JAMES A. FITZPATRICK NUCLEAR POWER PLANT

AMENDMENT TO FACILITY OPERATING LICENSE

Amendment No. 46
License No. DPR-59

ENVIRONMENTAL IMPACT APPRAISAL BY THE OFFICE OF NUCLEAR REACTOR REGULATION

SAMPLING LOCATIONS

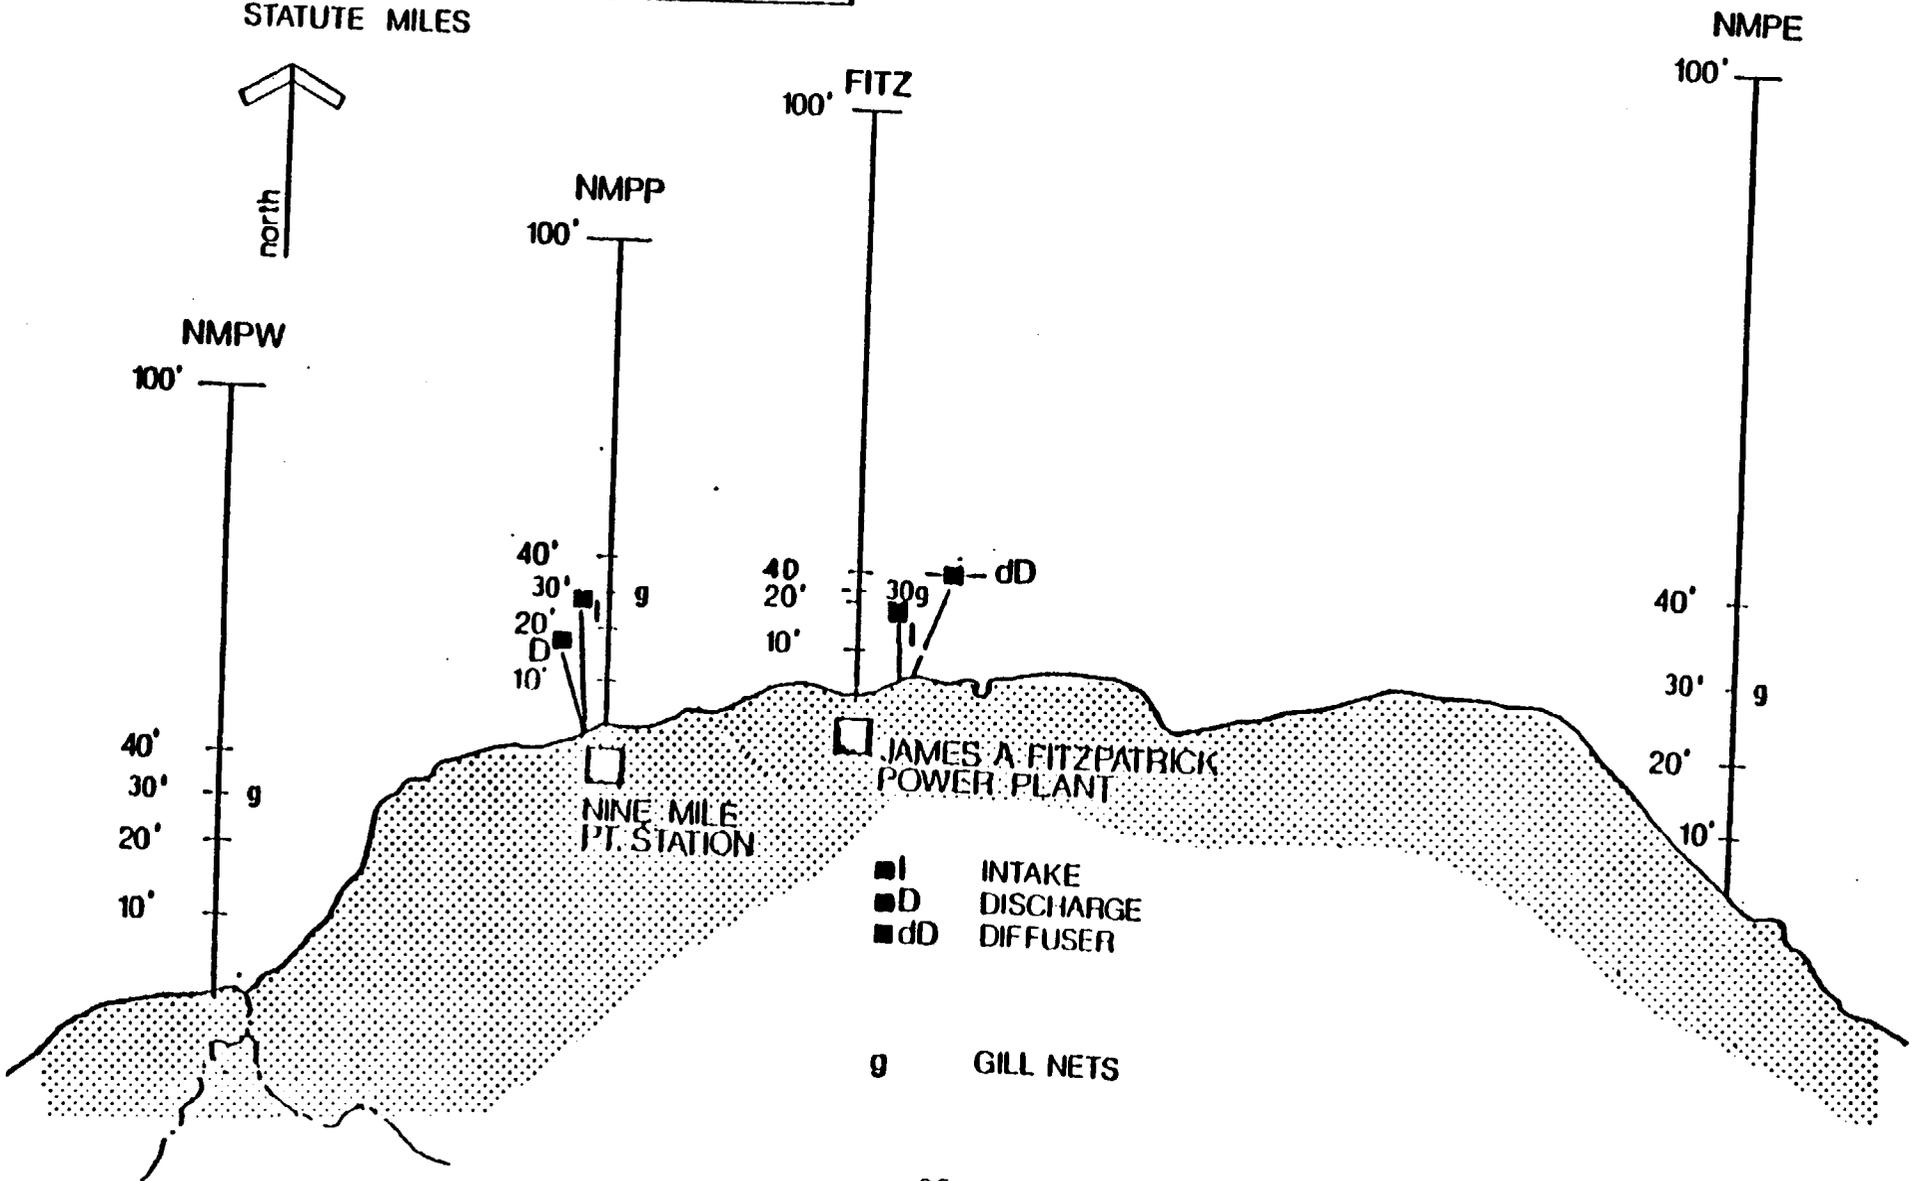
Monthly bottom gill nets shall be set at the 30' depth at all four transects (see Figure 4.1.1-1). See Table 4.1.1-1 for sampling schedule.
